CITY OF SAMMAMISH EBRIGHT CREEK FISH PASSAGE

30% SUBMITTAL

B CULVERT SECTION DETAIL
 12 N.T.S.

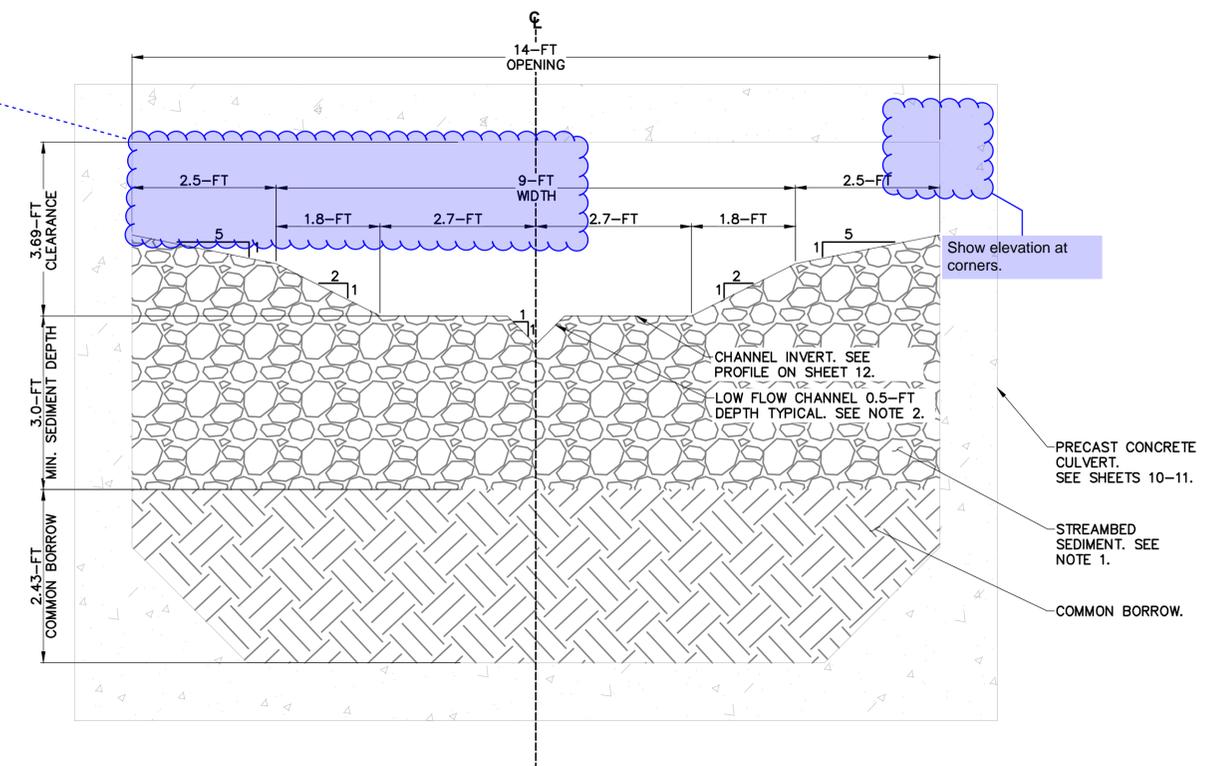
Maximize clearance from ground line to bottom of the top slab of the box culvert. Our experience with Zackuse shows that sediment transport/deposition into and through the box culvert can create maintenance problems for maintaining stream flows. Maximizing clearance will allow crews to enter box culvert to maintain if necessary.

Add a note on occasional placement of large boulders within the culvert, per Sheet 12.

PAVEMENT SECTION
NTS

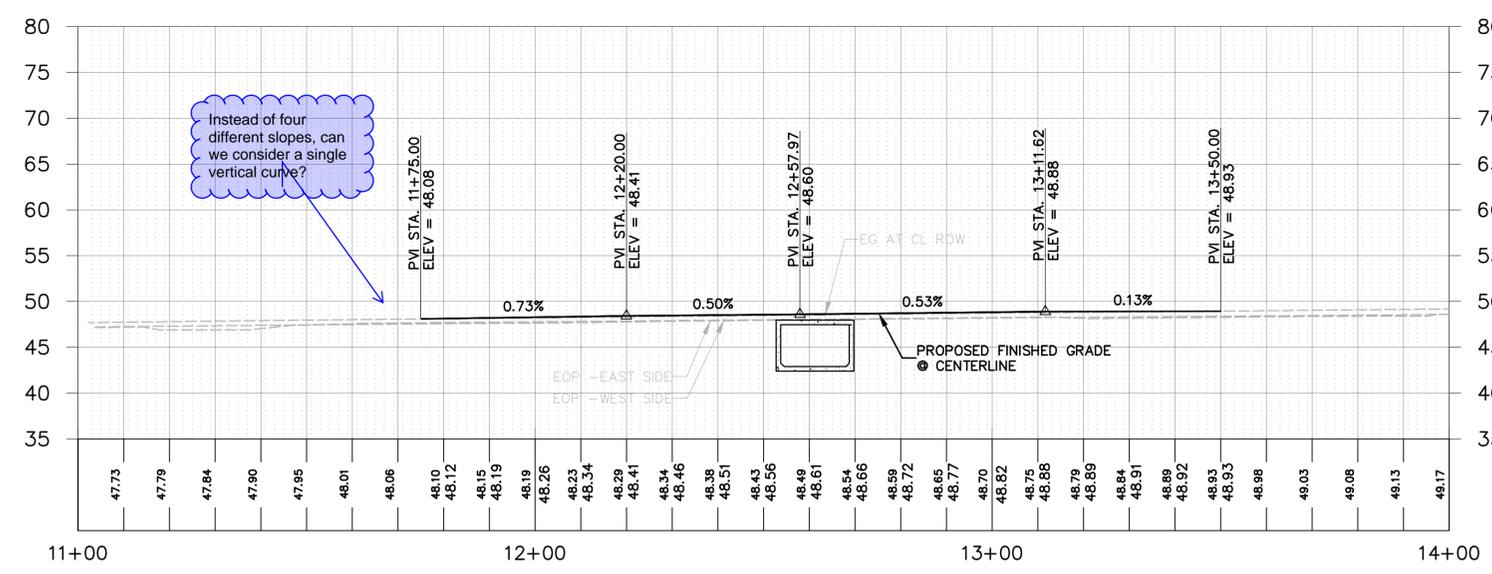
Update full-depth restoration to match PW Standards for minor arterial.

EBRIGHT CREEK FISH PASSAGE
CITY OF SAMMAMISH
GUARDRAIL AND CHANNELIZATION PLAN

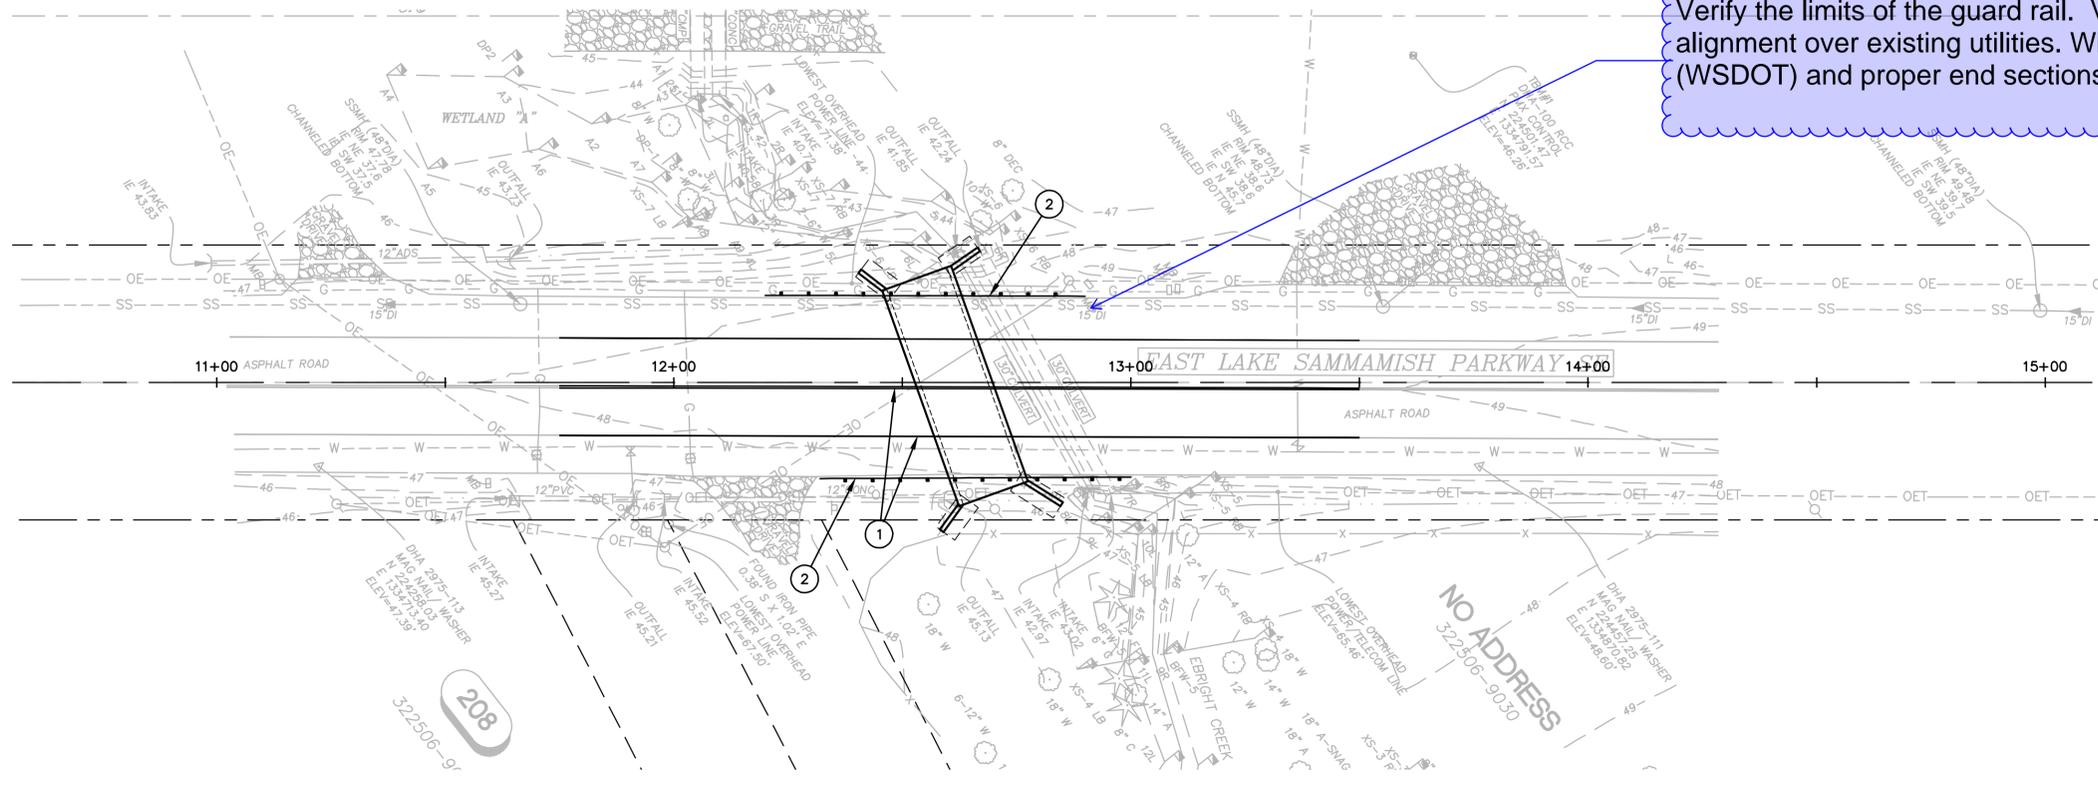
Verify the limits of the guard rail. Verify location of alignment over existing utilities. Will need details (WSDOT) and proper end sections.
